Project: State of North Dakota
ND State Capitol 14th Floor Renovation
Bismarck, North Dakota

RE: Addendum #1

State of North Dakota
Capitol Visitor Enhancements – Exterior Signage
Bismarck, North Dakota

ADDENDUM E1
J2 Studio Architecture + Design
Bismarck, North Dakota

1 Site Plan - Area A
Scale: 1" = 100'-0"

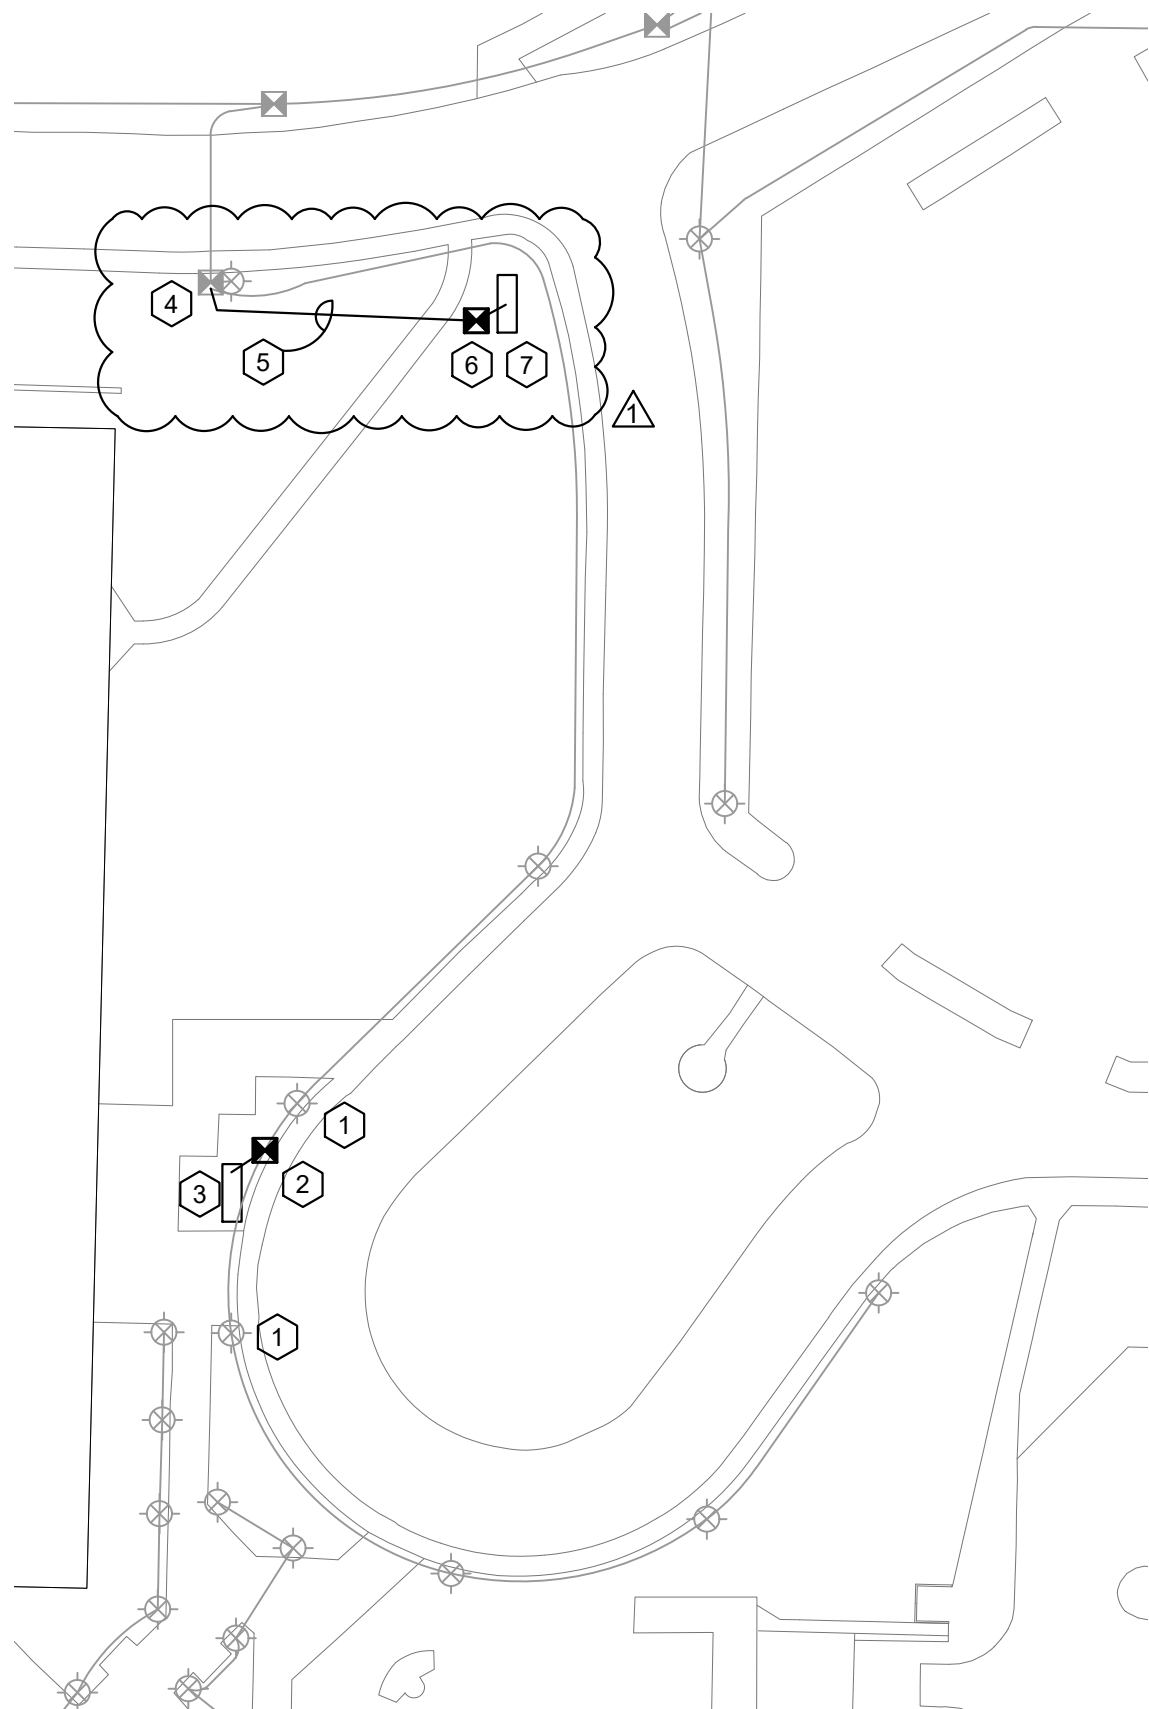
4. Drawings 1/A102; revise as follows and per attachment A1.
 - a. Add additional Pedestal Sign Type 1 at the location indicated on attachment A1; located northeast of the J-Wing.

2 AREA 2 ELECTRICAL PLAN - JUDICAL WING ENTRANCE
1" = 50'

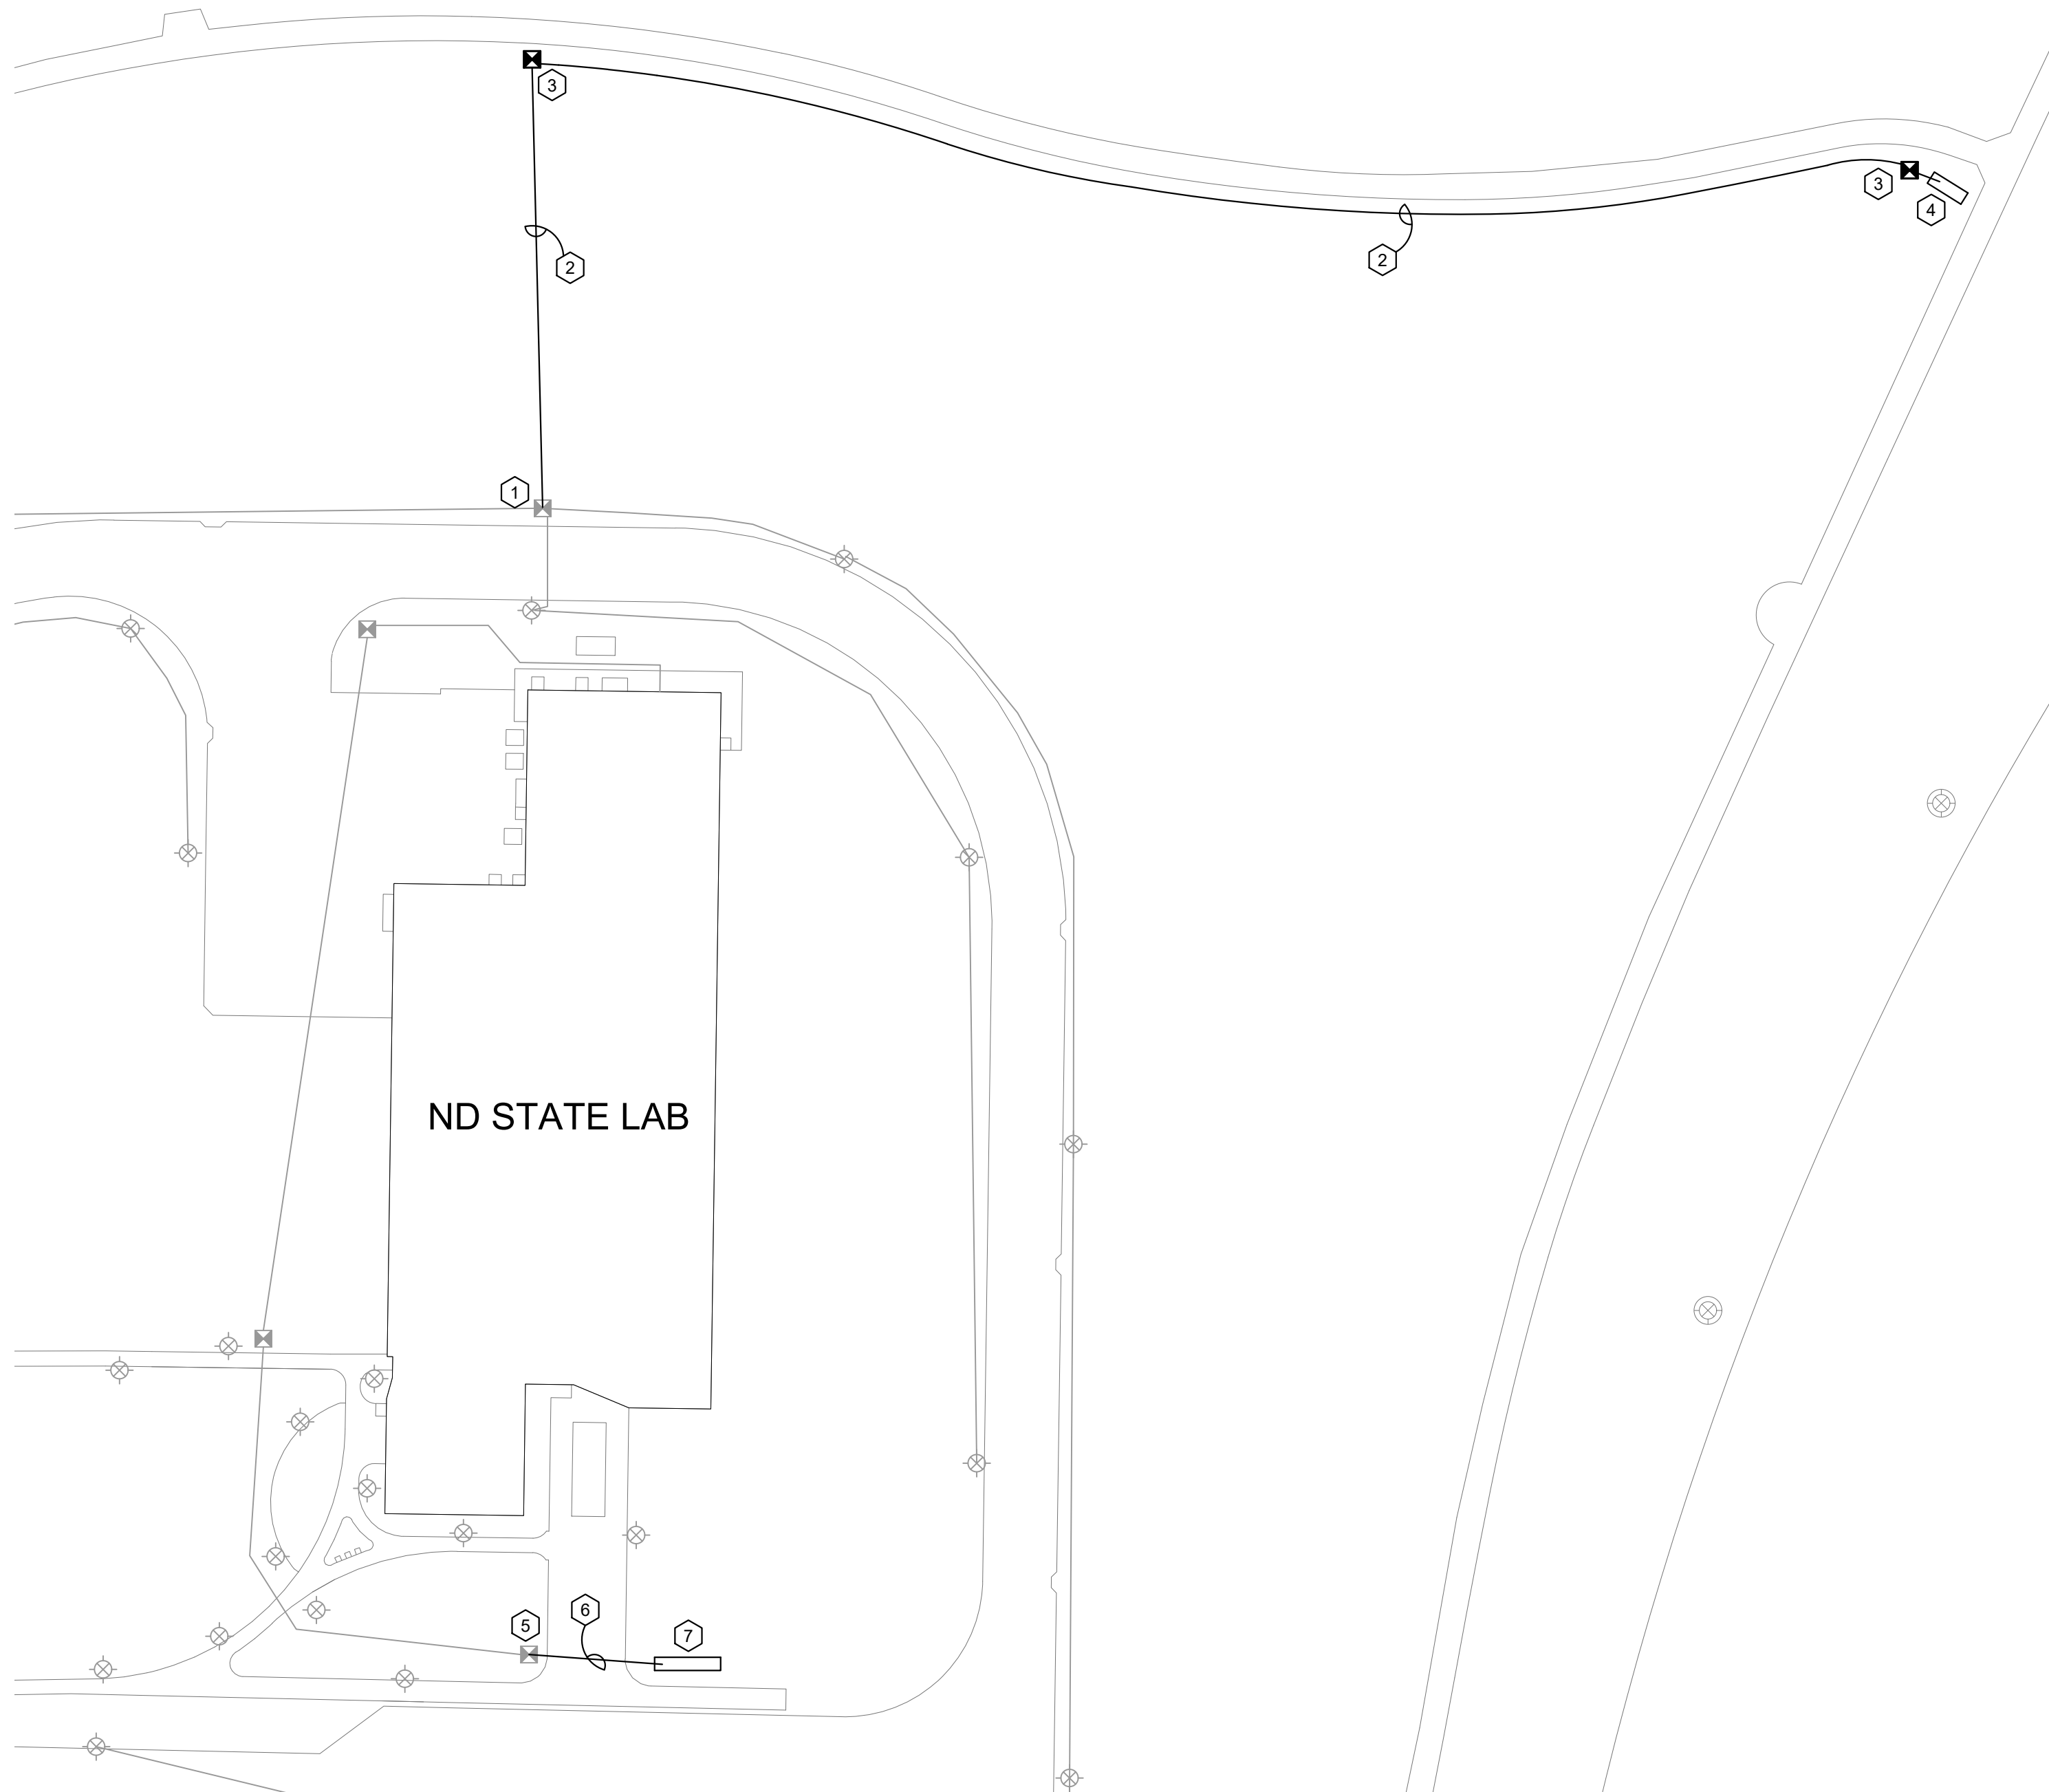
1. Detail 1: Area 1 Electrical Plan – Northwest Pedestrian Path:
 - a. Refer to revised drawing for Alternate Bid #E3 notation for all work associated with the ND State Lab monument sign. No work associated with this sign location is to be included in Base Bid.
2. Detail 2: Area 2 Electrical Plan – Judicial Wing Entrance:
 - a. Refer to revised drawing for an additional pedestal sign location.

- EXISTING DIRECT EMBED CONCRETE POLE TYPE LIGHT FIXTURE TO REMAIN. EXISTING LIGHTING CIRCUIT APPEARS TO BE FED FROM FEED POINT LOCATED AT THE SOUTHEAST CORNER OF THE MAINTENANCE SHOP - VERIFY WITH FACILITY MANAGEMENT STAFF. AS REQUIRED, EXCAVATE DOWN ALONG POLE TO EXPOSE CONDUIT/CABLE ENTRY TO ALLOW CIRCUITRY MODIFICATIONS. REMOVE AND REPLACE CONCRETE PAD IF REQUIRED.

- PROVIDE NEW IN-GROUND BOX OVER EXISTING CIRCUITRY. EXISTING CIRCUITRY IS UNKNOWN IF IT IS ROUTED IN CONDUIT OR DIRECT BURIED.
 - IF IN CONDUIT: DISCONNECT CIRCUITRY IN NORTH LIGHT FIXTURE AND PULL BACK TO SOUTH FIXTURE LOCATION. MODIFY CONDUIT(SIZE TO MATCH EXISTING) TO BE ROUTED INTO NEW IN-GROUND BOX. PROVIDE NEW 2-#8+EGC CONDUCTORS BETWEEN BOTH EXISTING LIGHTS AND NEW IN-GROUND BOX.

- IF DIRECT BURIED, DISCONNECT IN NORTH LIGHT FIXTURE AND EXPOSED ADEQUATE LENGTH OF EXISTING CONDUCTORS TO ALLOW RE-ROUTING OF CONDUCTORS FROM SOUTH FIXTURE INTO NEW IN-GROUND BOX. PROVIDE NEW 2-#8+EGC DIRECT BURIED CONDUCTORS FROM NEW IN-GROUND BOX TO NORTH LIGHT FIXTURE.

- PROPOSED PEDESTAL SIGN LOCATION. REFER TO SHEET E107, DETAIL 2 FOR INSTALLATION REQUIREMENTS. PROVIDE 3/4" CONDUIT WITH 2-#8+EGC CONDUCTORS BETWEEN NEW IN-GROUND BOX AND SIGN. DIRECT BURIED RATED CONNECTOR BLOCK EQUAL TO ILLSCO PED SERIES. PROVIDE LIGHTING OF ONE SIDE OF SIGN. CONTRACTOR TO VERIFY EXISTING SUPPLY VOLTAGE (277V) AND COORDINATE WITH LIGHTING FIXTURE SUPPLIER. CIRCUIT APPEARS TO BE FED FROM EXISTING FEEDPOINT LOCATED AT THE SOUTHEAST CORNER OF THE MAINTENANCE BUILDING.

2 AREA 5 ELECTRICAL PLAN - GOVERNOR'S RESIDENCE
1" = 50'

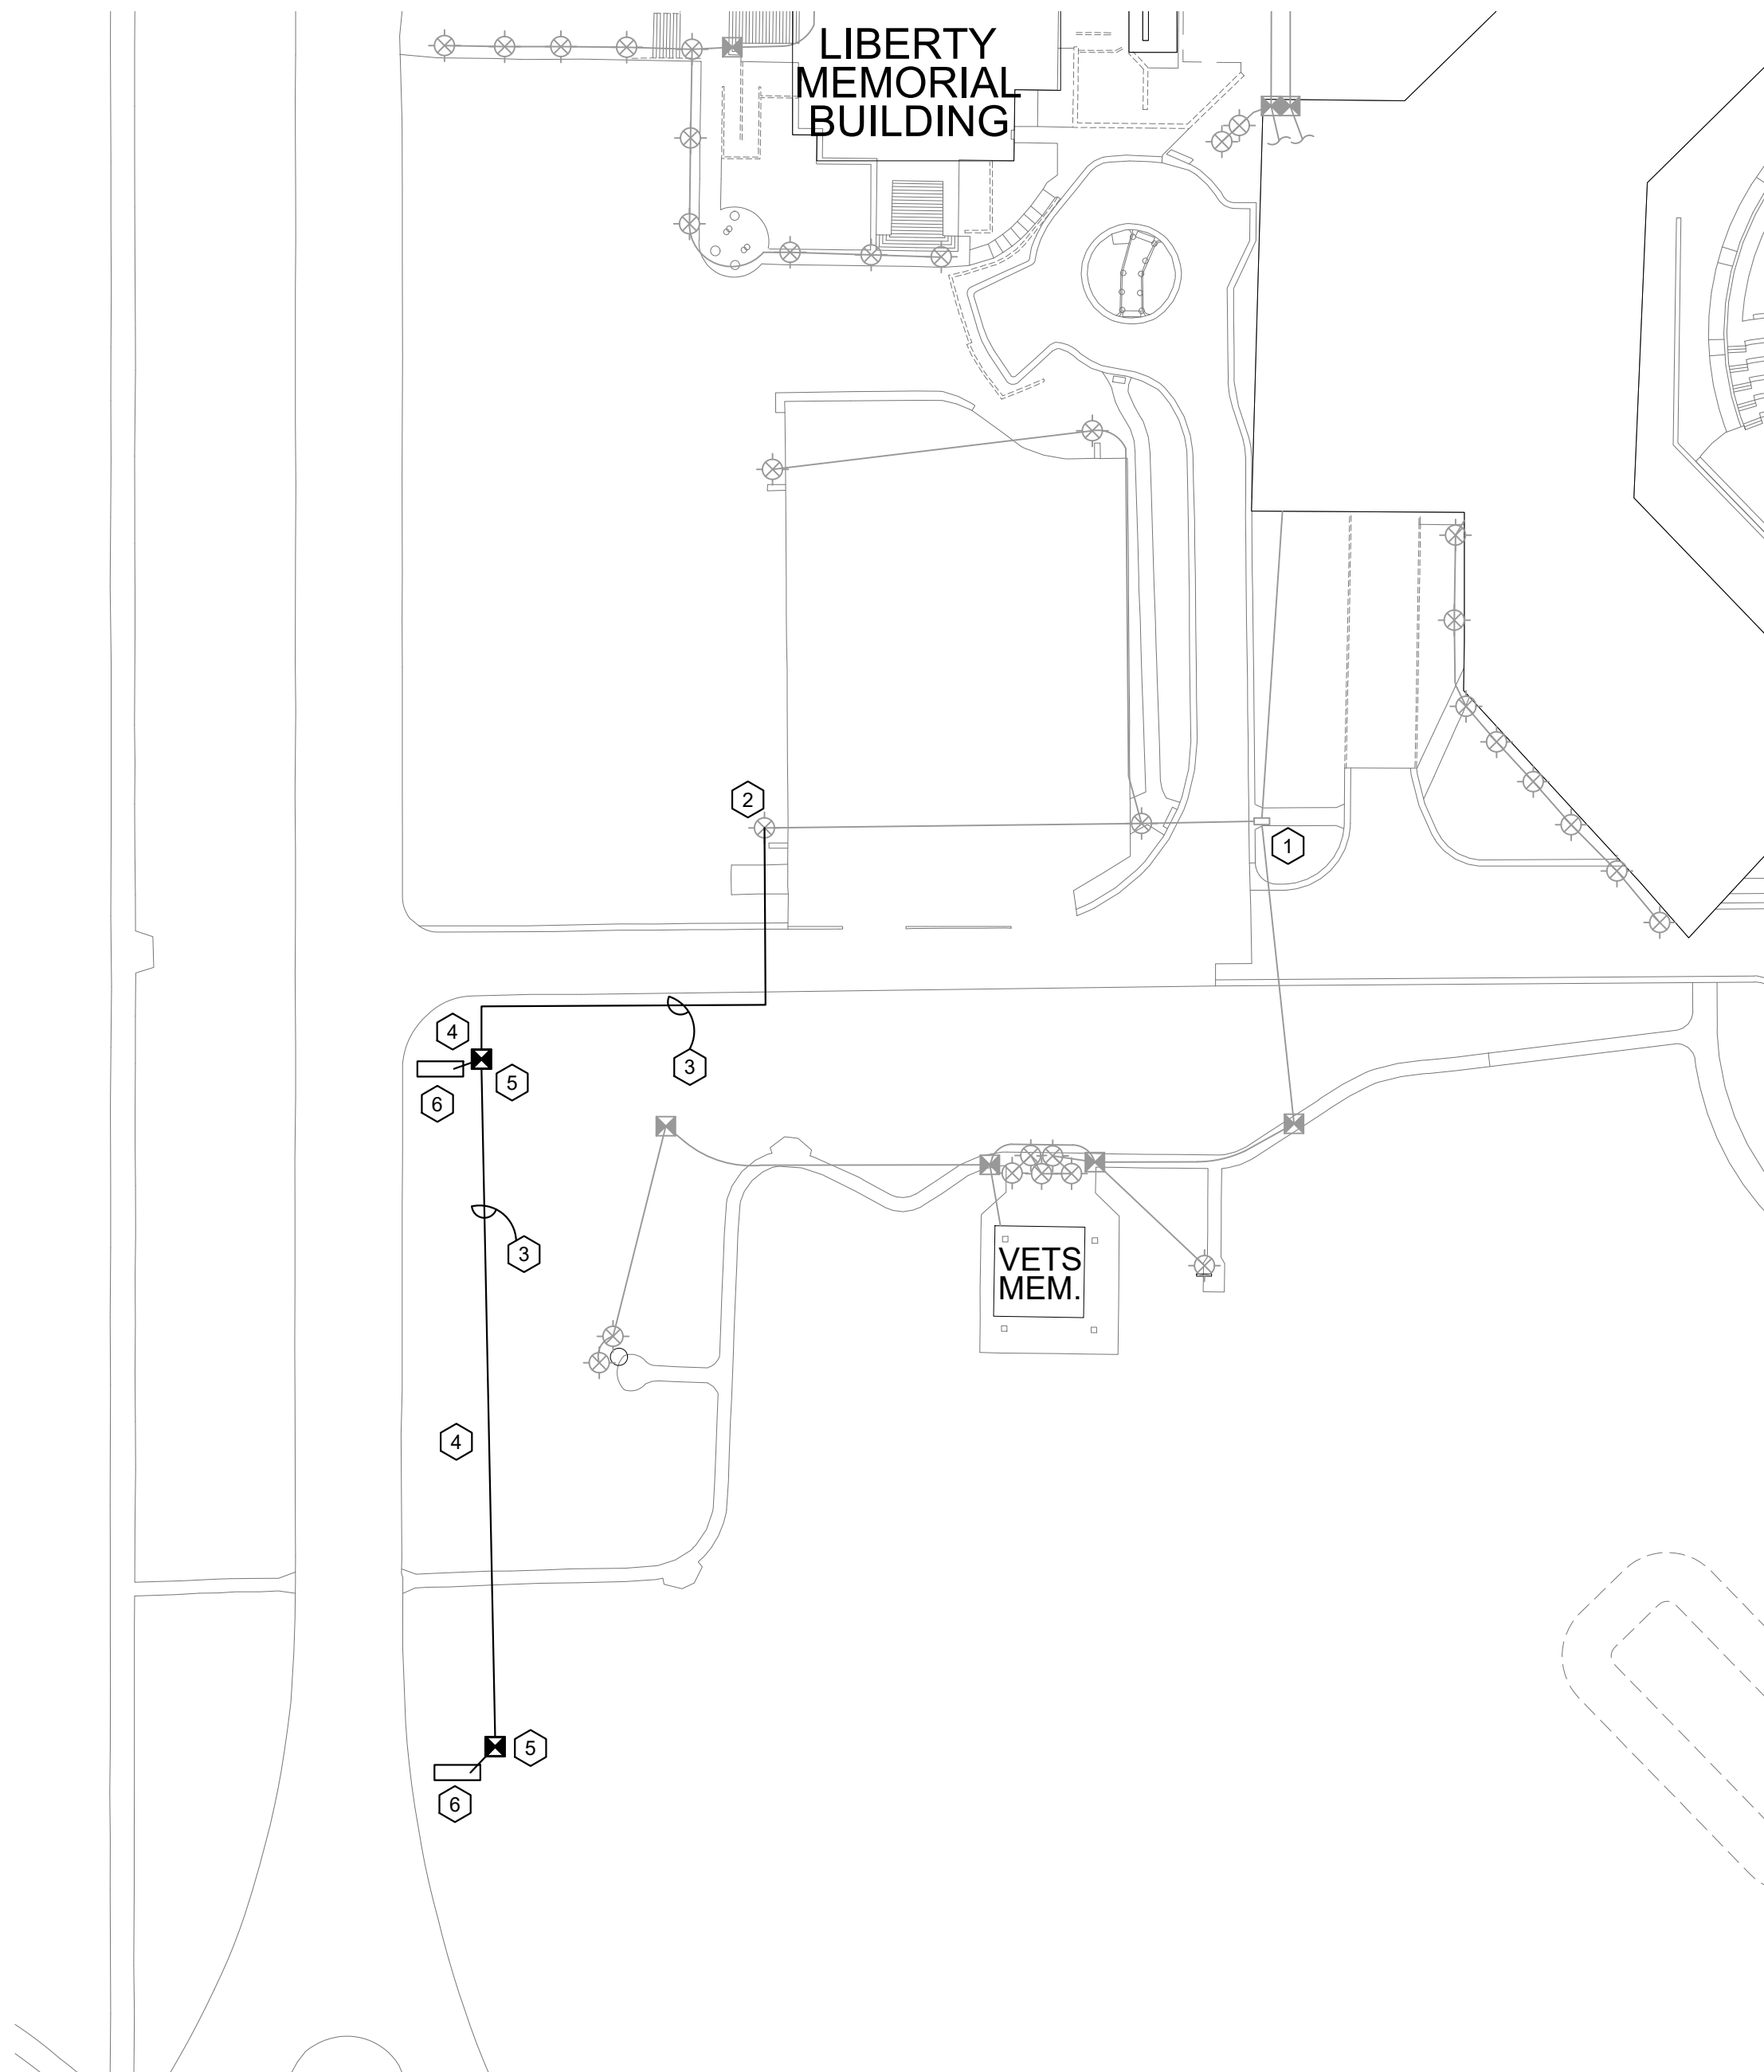
1. Detail 2: Area 5 Electrical Plan – Governor's Residence:
 - a. Refer to revised drawing for Alternate Bid #E4 notation for all work associated with the ND Governor's Residence monument sign. No work associated with this sign location is to be included in Base Bid.

- 1 **ALTERNATE BID #E4** EXISTING IN-GROUND BOX WITH EXISTING LIGHTING CIRCUIT FED FROM GOVERNOR'S RESIDENCE. REMOVE EXISTING DIRECT BURIED CONNECTOR BLOCK AND PROVIDE A NEW 6-POSITION(VERIFY) DIRECT BURIED CONNECTOR BLOCK EQUAL TO ILLSCO PED SERIES TO CONNECT SIGN LIGHTING CIRCUITRY TO EXISTING LIGHTING CIRCUITRY.
- 2 **ALTERNATE BID #E4** PROPOSED MONUMENT SIGN LOCATION. REFER TO SHEET E107, DETAIL 1 FOR INSTALLATION REQUIREMENTS. PROVIDE 3/4" CONDUIT WITH 2-#8+EGC CONDUCTORS BETWEEN EXISTING IN-GROUND BOX AND SIGN. PROVIDE SINGLE POINT CONNECTION TO INTERNALLY ILLUMINATED SIGNAGE. CONTRACTOR TO VERIFY EXISTING SUPPLY VOLTAGE (120 VOLT) AND COORDINATE WITH LIGHTING FIXTURE SUPPLIER.
